## OVEN MOUNTAIN PUMPED HYDRO ENERGY STORAGE

# Amendment Report

Oven Mountain Pumped Hydro Storage Pty Ltd

E230869c RP1

Oven Mountain Pumped Hydro Energy Storage Project  
Amendment Report  
OMPS Pty Ltd  
Figure 1.5

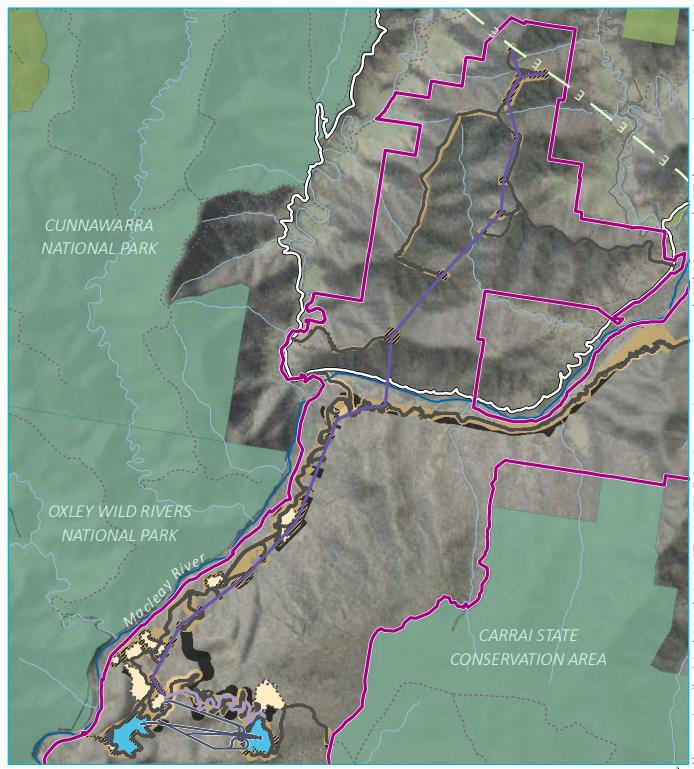
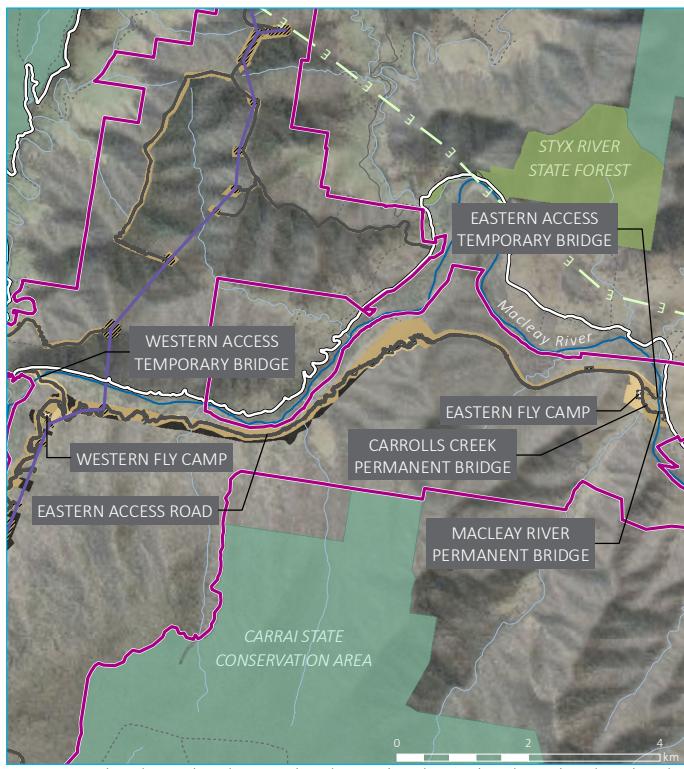
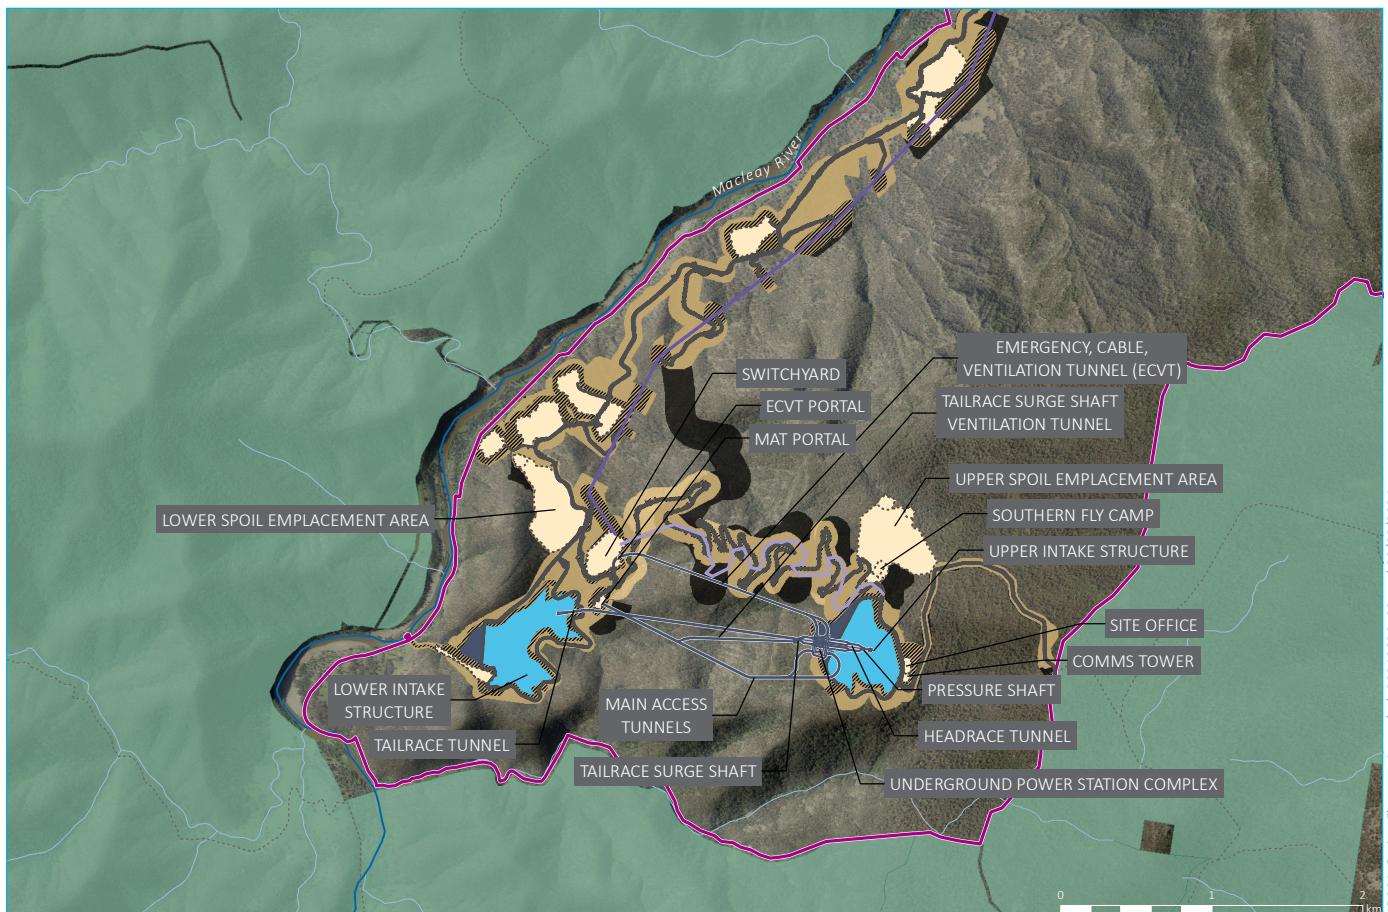
Project Element	Description of amendment	Reason(s) for amendment
<b>Internal roads and bridges</b>		
Eastern Access Road (EAR) refinement	Realignment of the EAR (EAR) refinement	<ul style="list-style-type: none"> <li>To reduce need for earthworks, improve road safety and address drainage issues.</li> </ul>
Bridges	A temporary bridge will be utilised prior to the construction of the two permanent bridges near Smiths Bluff (referred to as Eastern Access Temporary Bridge). A secondary, temporary access is proposed via the construction of a new, temporary bridge crossing of the Macleay River about 600 m north-east of Georges Junction (referred to as Western Access Temporary Bridge).	<ul style="list-style-type: none"> <li>Improve cut and fill balance to reduce requirements of permanent spoil emplacement associated with road works.</li> <li>Reduce the period of internal road construction and therefore overall construction period, and improve effectiveness of emergency response measures (access and egress).</li> </ul>

Project Element	Description of amendment	Reason(s) for amendment
Upper Dam Access Road (UDAR) refinement	Realignment of the UDAR (including removal of a large north-south connecting section of road).	<ul style="list-style-type: none"> <li>Avoid direct impacts on the habitat of the brush tailed rock wallaby and in response to submissions from Biodiversity, Conservation and Science (BCS) Directorate of NSW DCCEEW.</li> </ul>
<b>Construction methods and requirements</b>		
Temporary or fly camps	While fly camps were previously anticipated for the project, up to three fly camps are confirmed to be required and will be located near Smiths Bluff (Eastern fly camp), the intersection of the Main Access Road and the EAR (Western fly camp) and the upper reservoir (within spoil emplacement area) (Southern fly camp). The camps will each accommodate about 20 workers and up to 90 workers depending on the ultimate configuration, and would be established within the first year of construction.	<ul style="list-style-type: none"> <li>To reduce pressure on local accommodation sources.</li> </ul>

Spoil emplacement	Two permanent spoil emplacement (PSE) areas are now proposed, with the areas both having increased in size to accommodate revised spoil estimates, reduced stockpile heights and slope angles.	<ul style="list-style-type: none"> <li>To take into account spoil quantities generated from an optimised 900MW design</li> <li>To respond to stakeholder feedback regarding landform and erosion risks</li> <li>To avoid direct impacts and further minimise indirect impacts to <i>Pultenaea</i> sp. Werrikimbe NP (<i>Pultenaea rubescens</i>)</li> </ul>
<b>Underground arrangement and sizing</b>		
Underground arrangement and sizing for improved generation capacity	An amended underground arrangement and tunnel sizes to reflect up to around 900 MW generation and at least eight hours of storage capacity. Re-location of MAT portal is proposed to align with amended arrangement.	<ul style="list-style-type: none"> <li>The EIS presented a preliminary design initially based on a 600 MW generation capacity, with intent to optimise the design up to 900 MW capacity.</li> <li>To confirm a 900 MW generation scheme with at least eight hours energy storage, an increase in the cavern size of the powerhouse is needed.</li> </ul>

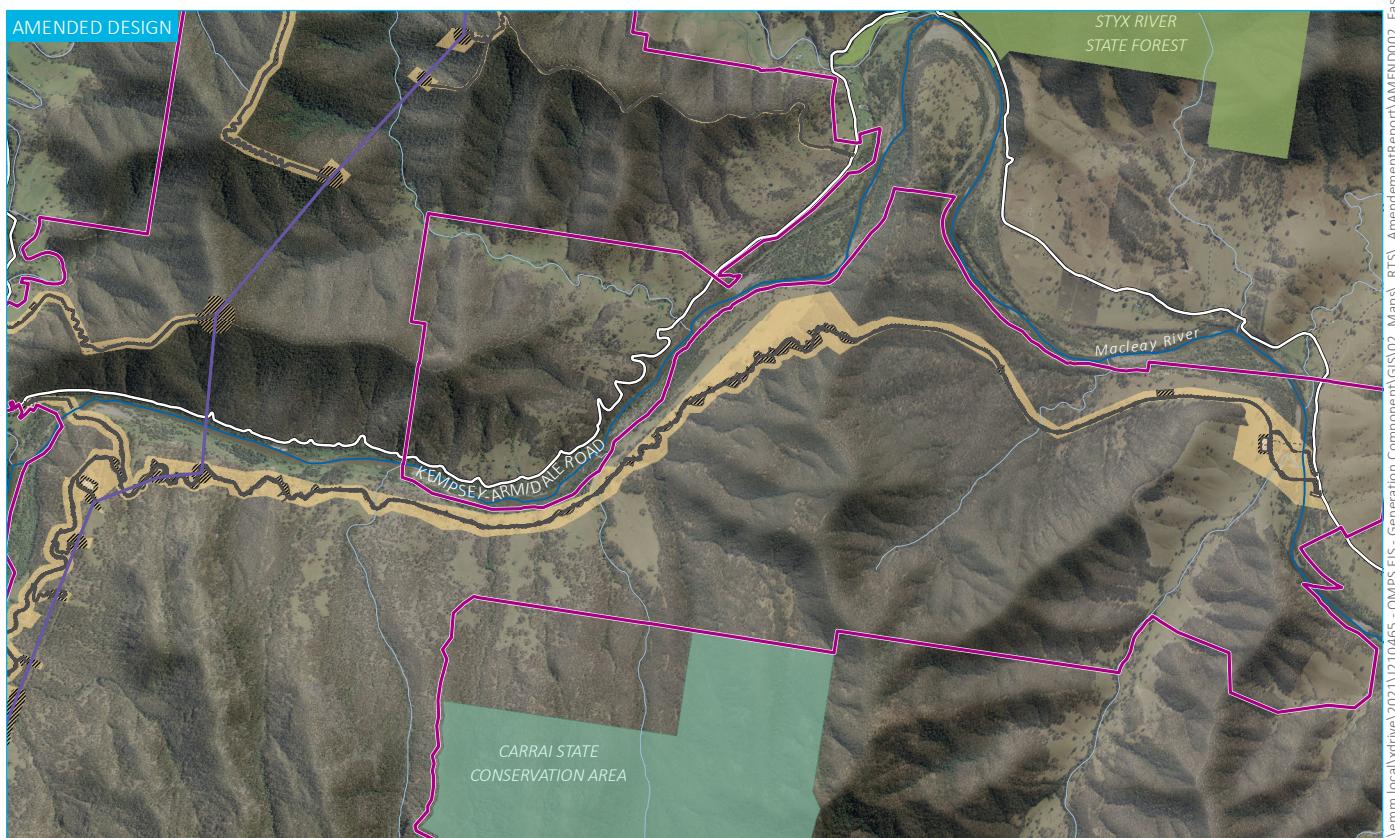
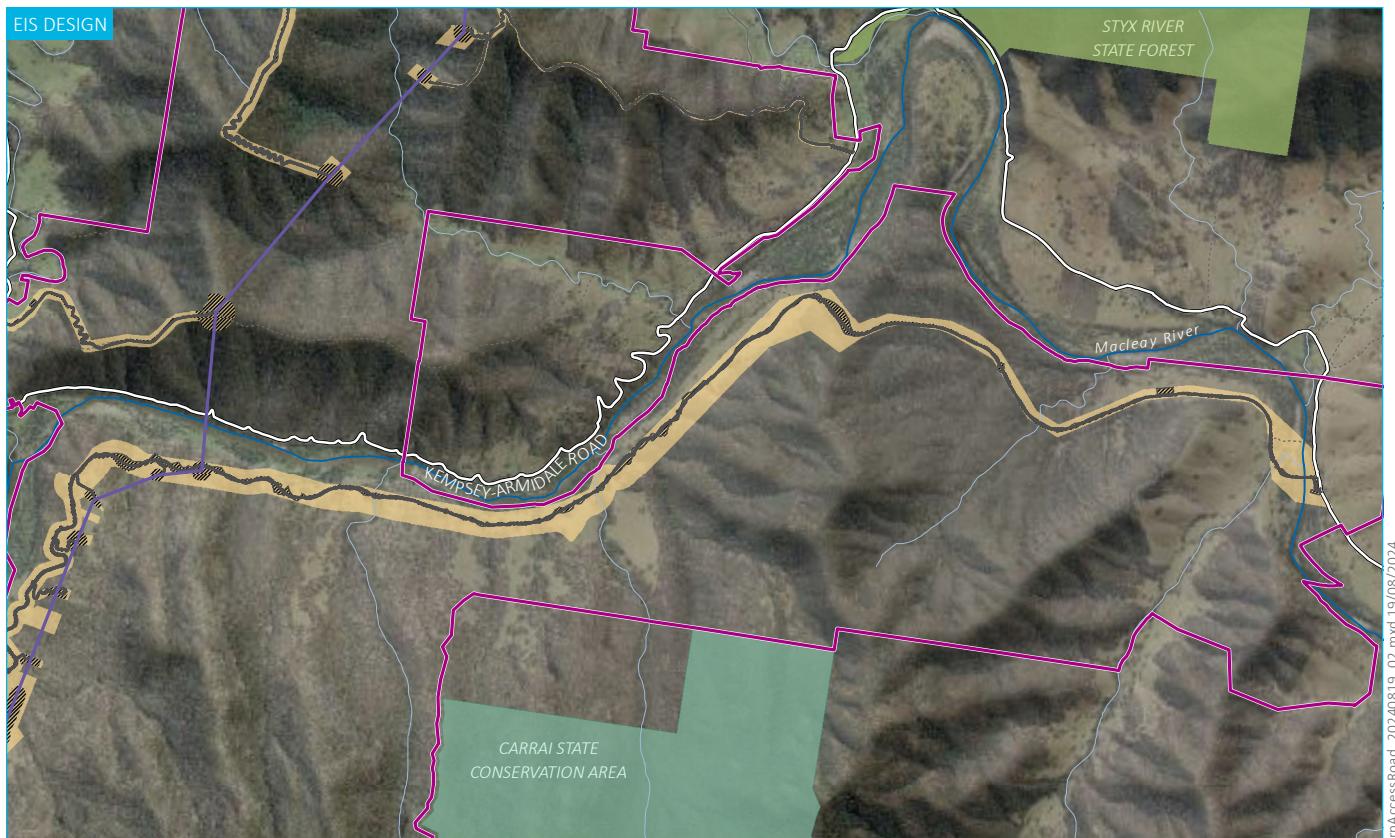
This change will also shorten the period of internal road construction, thereby reducing the overall construction timeline and enhancing the effectiveness of emergency response measures for access and egress.

The alignment of the amended EAR compared to the EIS is shown in Figure 3.2.

Figure 3.4 Cross-section and plan view of temporary bridge design

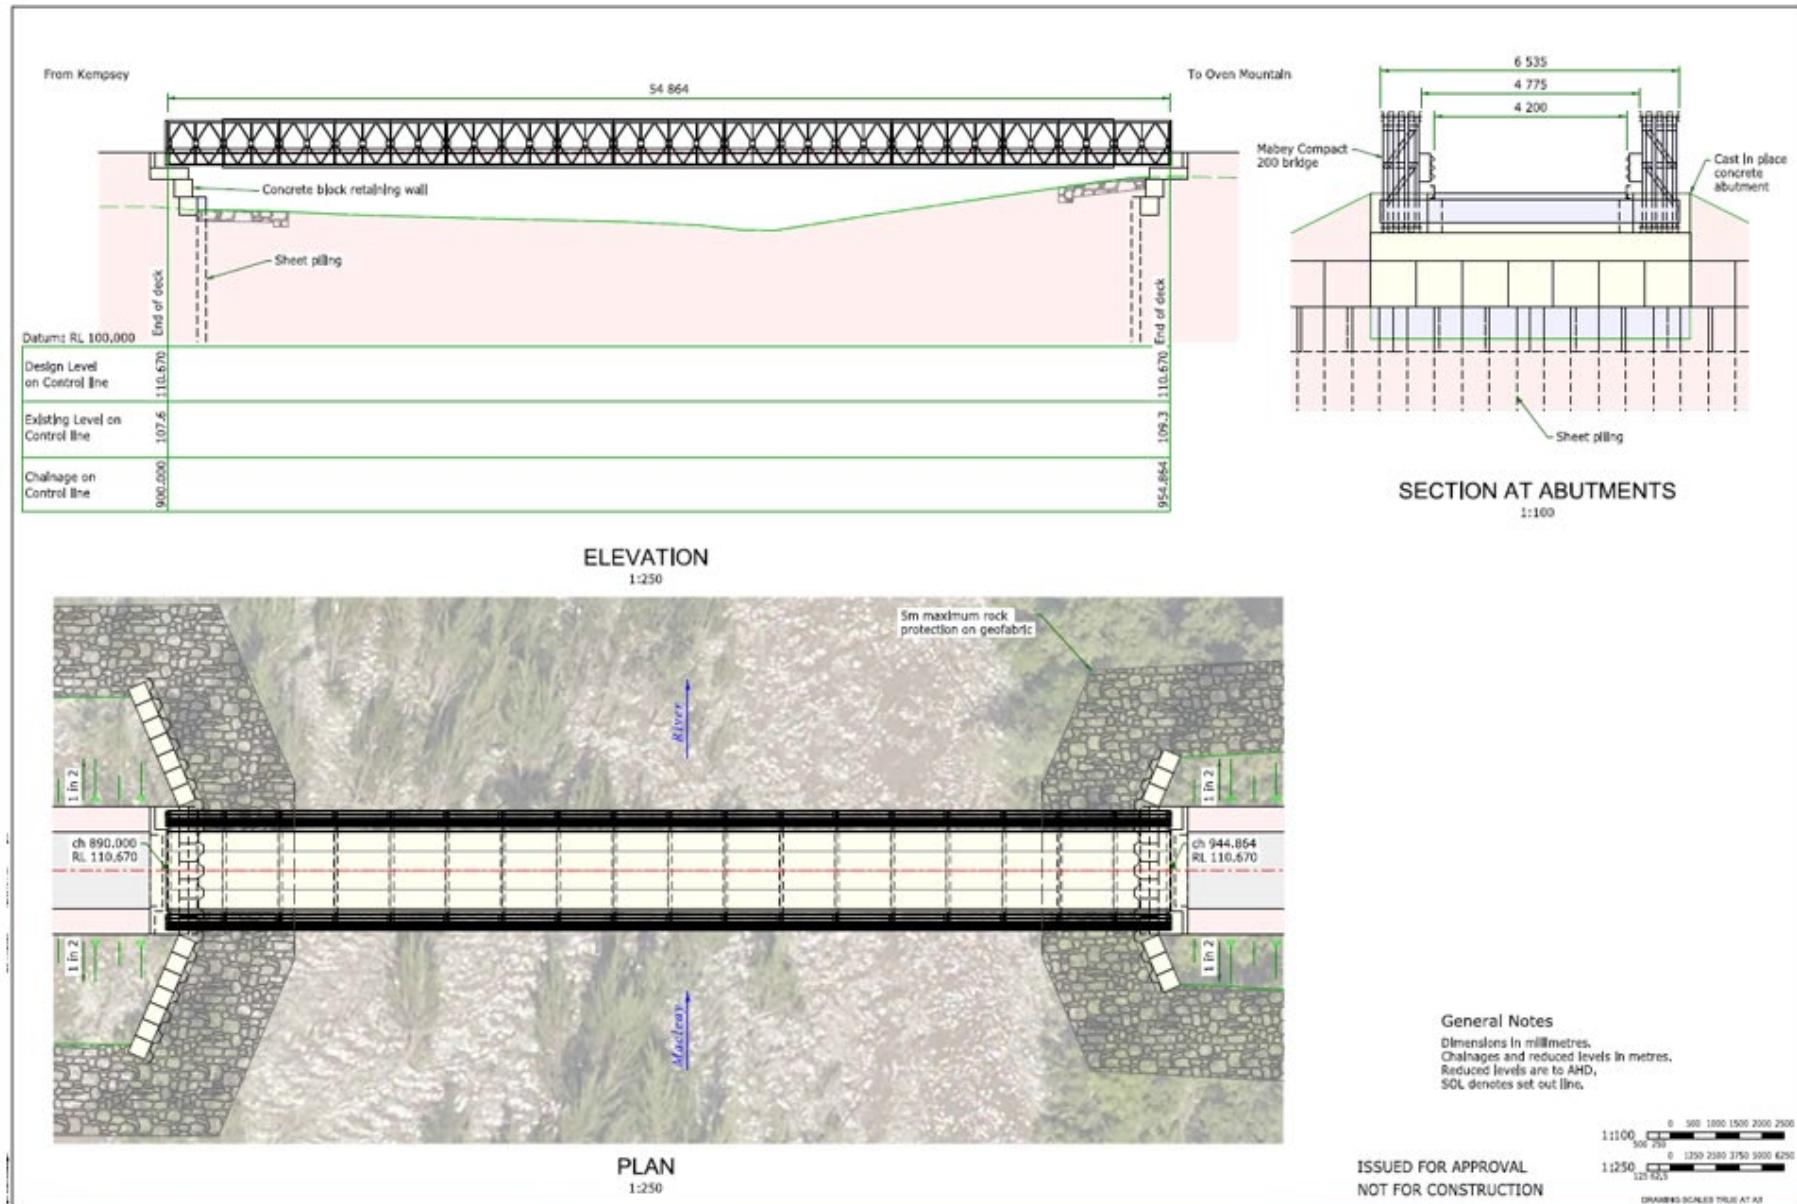
The indicative design of temporary bridges is shown in Figure 3.3. It is anticipated the WATB will be decommissioned upon the completion of the EAR, while the EATB will be decommissioned prior to the completion of the Smiths Bluff and Carrolls Creek permanent bridges.

Oven Mountain Pumped Hydro Energy Storage Project  
Amendment Report  
OMPS Pty Ltd  
Figure 3.13

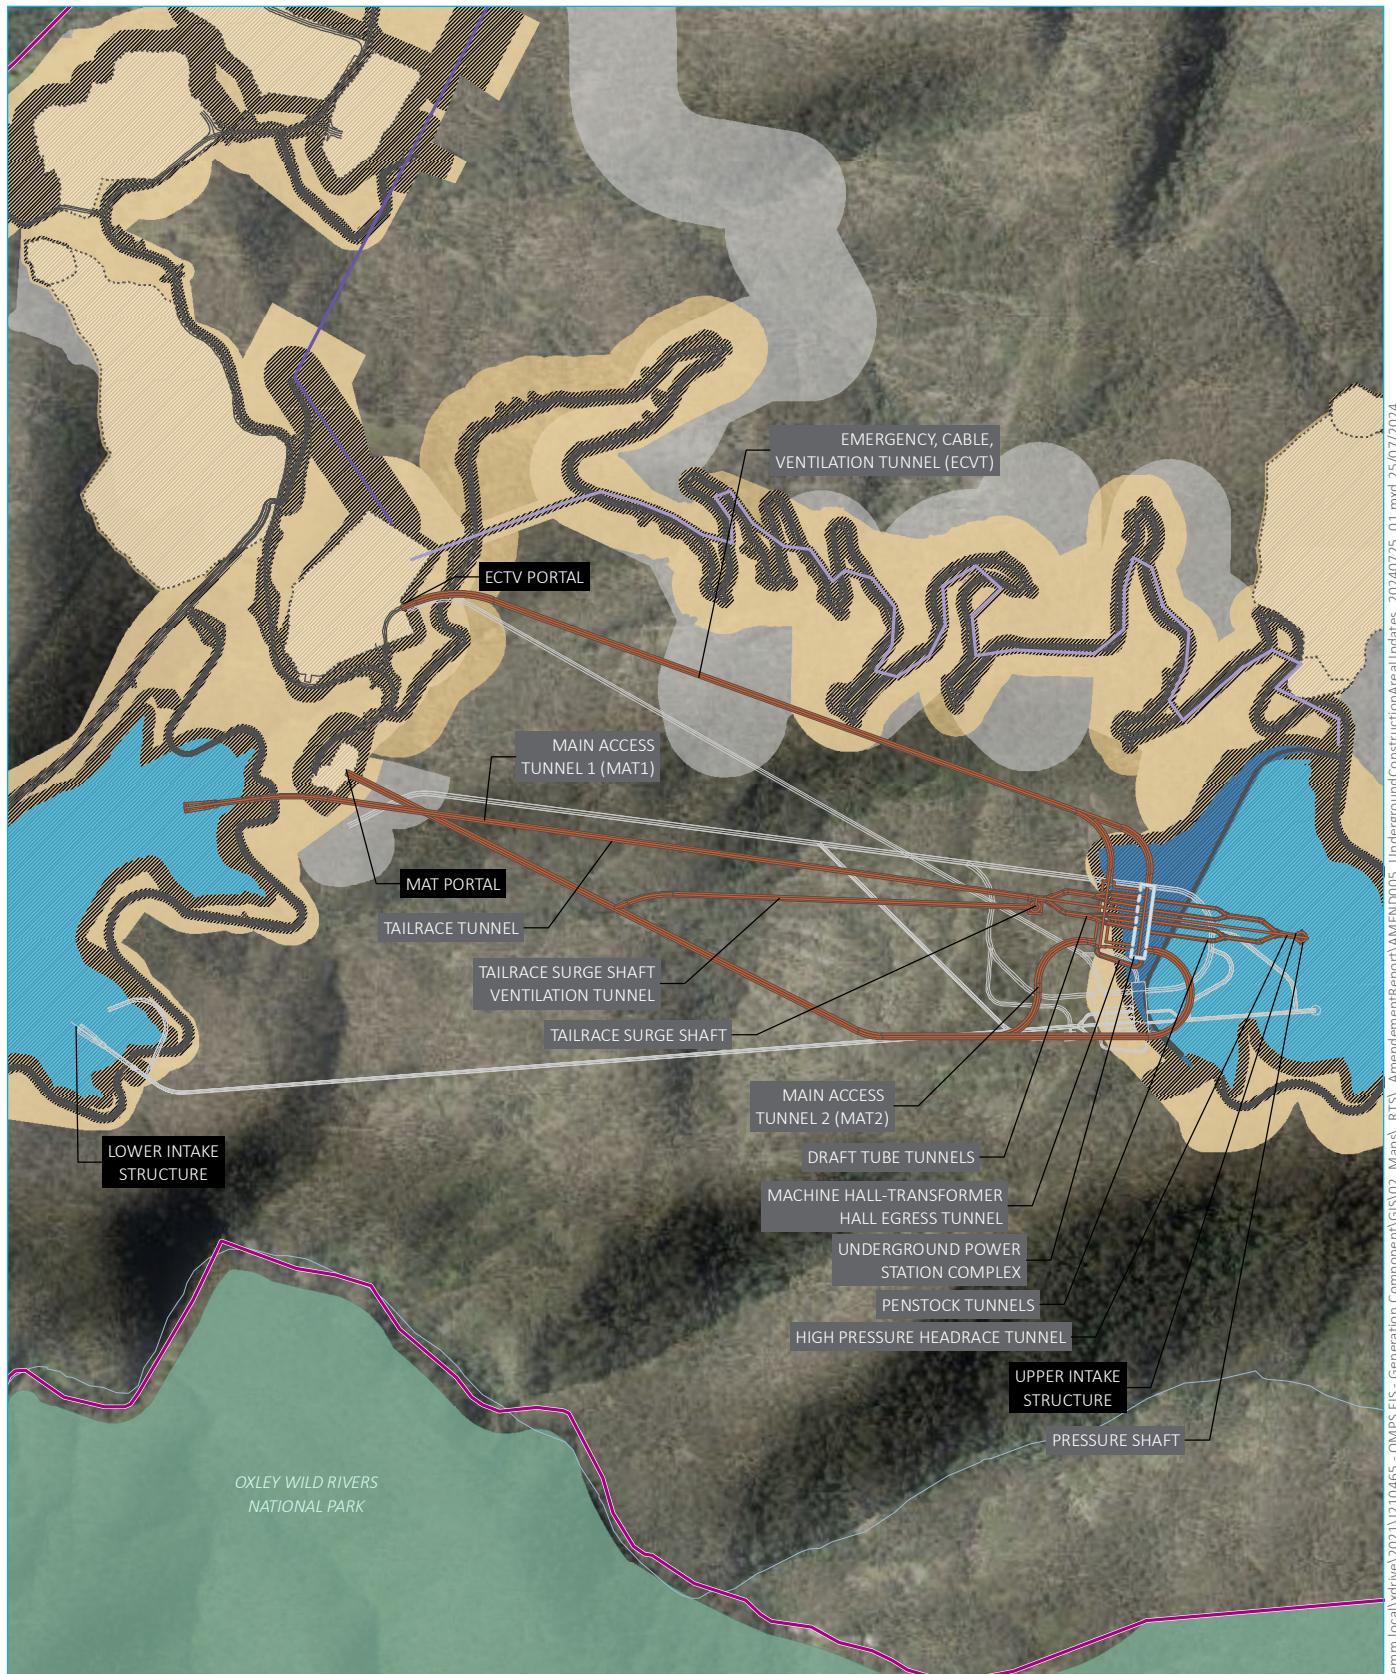
The design has been prepared to confirm the capacity of the Project to provide up to around 900 MW of electricity generating capacity and up to eight hours of energy storage at full generating capacity. This design includes a larger powerhouse cavern, a change in tunnel alignment, and re-location of the MAT portal to align with the change in underground arrangement. The revised underground arrangement is shown in Figure 3.13.

The change in underground arrangement and sizing effects the amount of spoil generated by the Project and therefore the need to amend the spoil emplacement design. No other changes to design or assessment are effected by this confirmed 900 MW underground arrangement.
